ESSB 6392: Design Refinements and
Transit Connections Workgroup | **Appendix C: Public comments**

ESSB 6392 Workgroup recommendations Public comment summary

Below is a summary of the comments received by participating agencies and the general public on the Workgroup's recommendations during the comment period from Sept. 13 to 24, 2010.

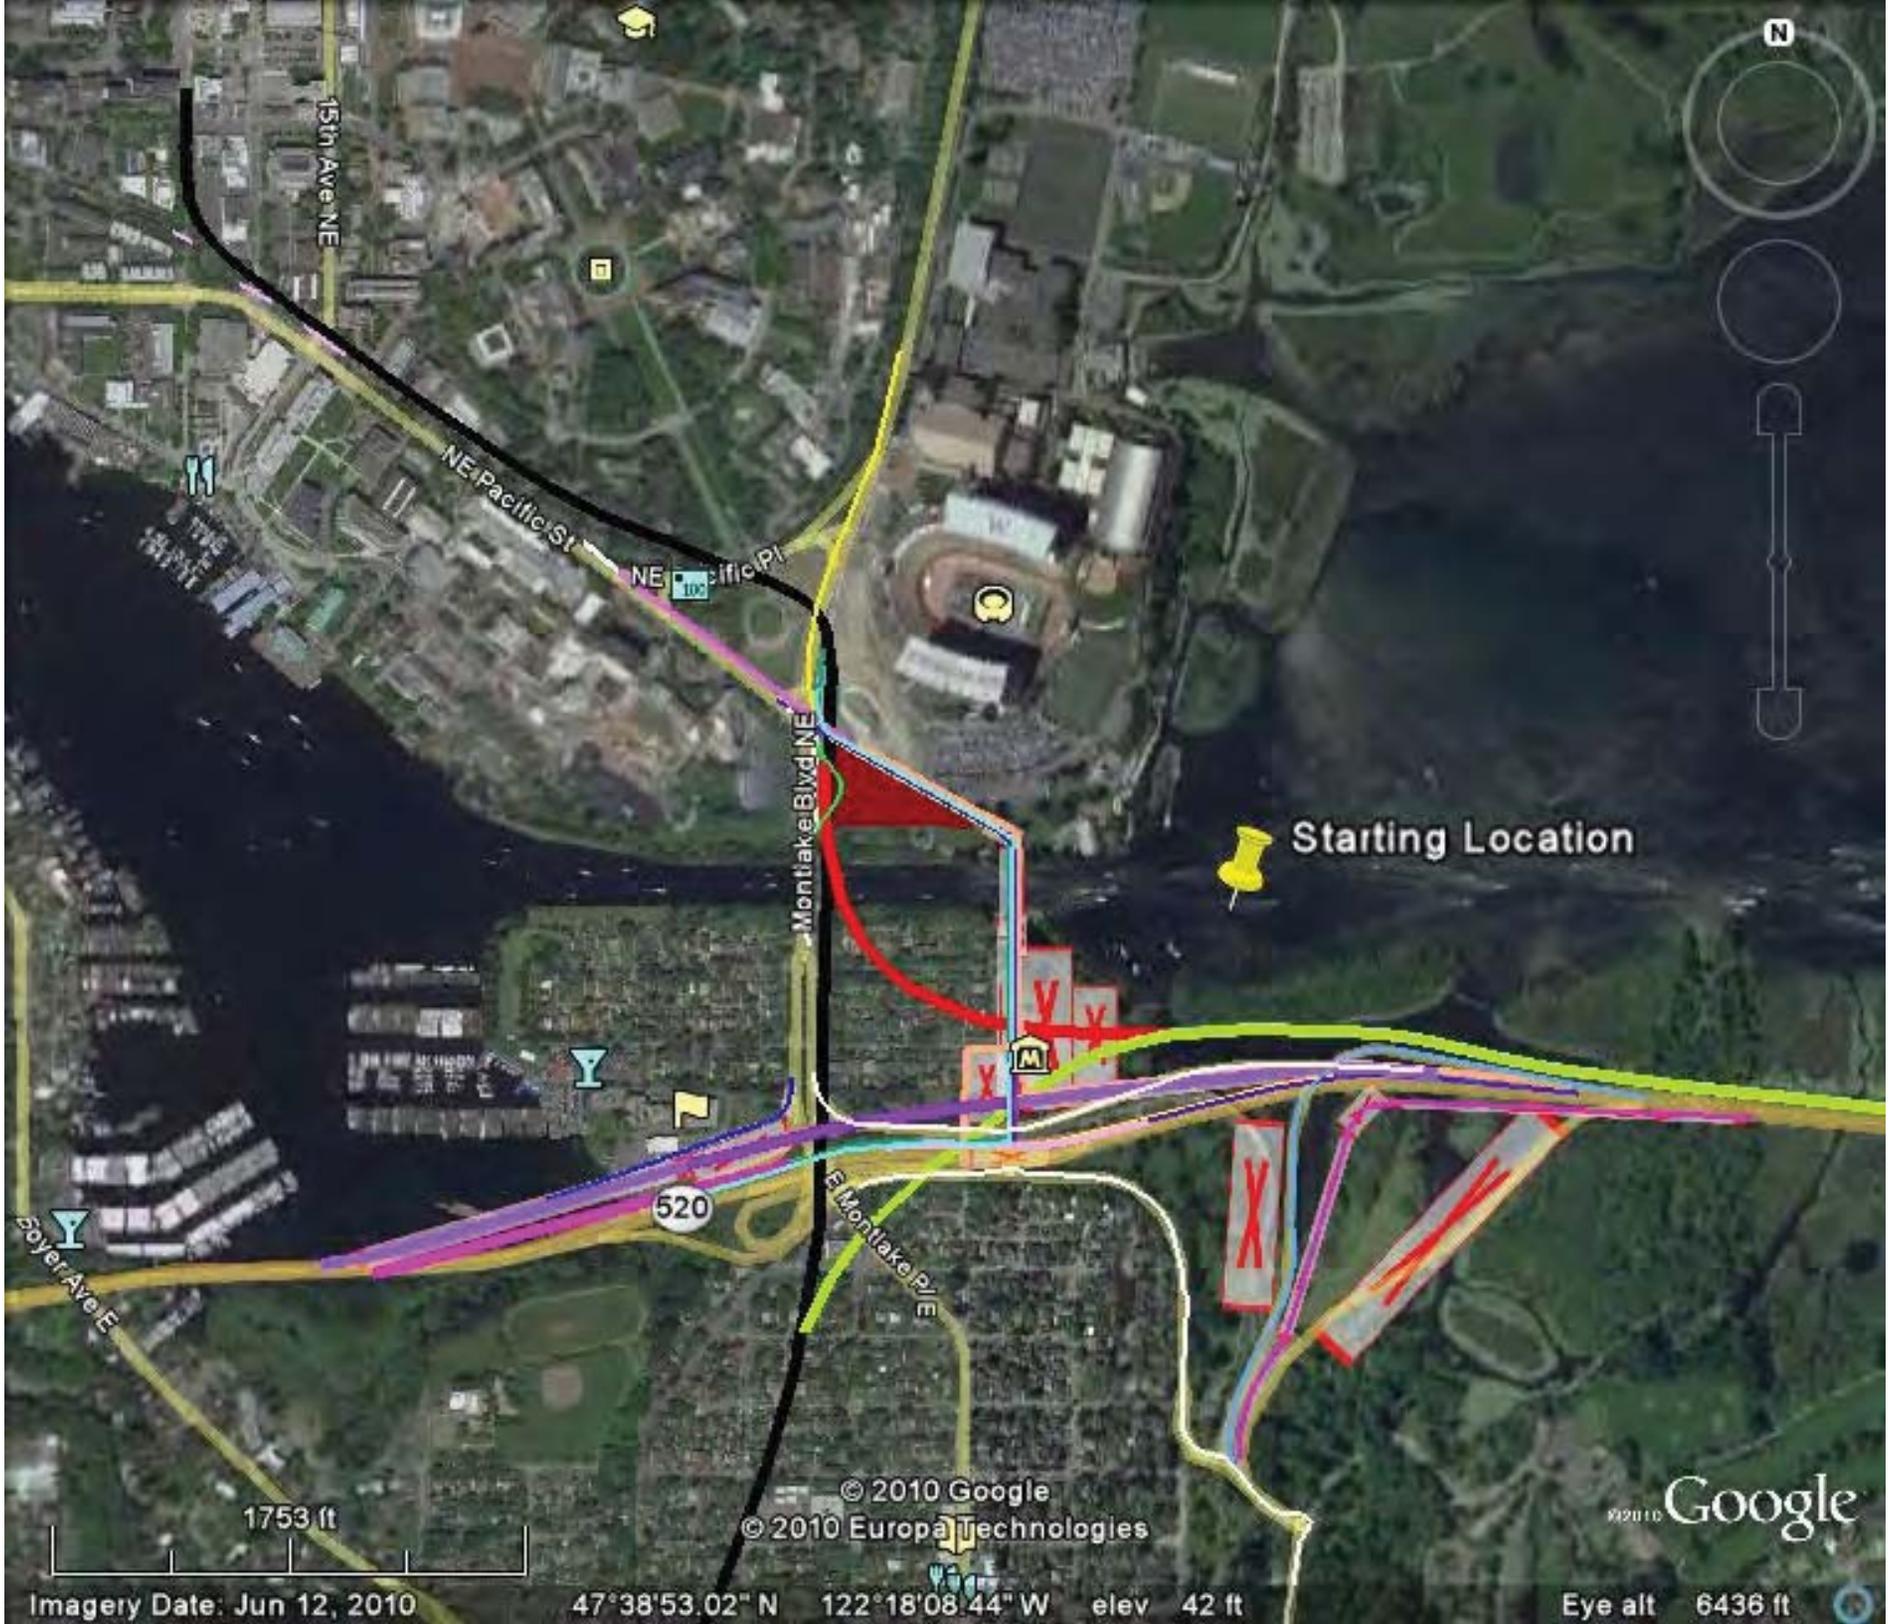
- 25) Maintain a general-purpose lane exit from Westbound 520 to Northbound Montlake Blvd. as a free right turn.
- 26) Do not install the traffic light just North of 520 on Montlake and do not add the ramp to Montlake Blvd. for both general purpose and HOV access to 520. Eliminate the Transit Stop at this location. This would reduce the width of 520 in this area by two lanes.

- 27) 24th Ave East does not need to be realigned across 520. The lid at this location needs to be reduced to save addition costs.

This proposed design will allow the existing footprint of 520 at Montlake to remain.

To test the viability of Option A+, close both East and Westbound ramps to Lake Washington Blvd. East for two months while the University of Washington is in session. Add a temporary traffic light on the North side on 520 at Montlake Blvd. for two months at the same time. The intersections at Boyer, East Roanoke, Montlake Blvd. and Pacific will be overwhelmed by the amount of traffic caused by the details of Option A.
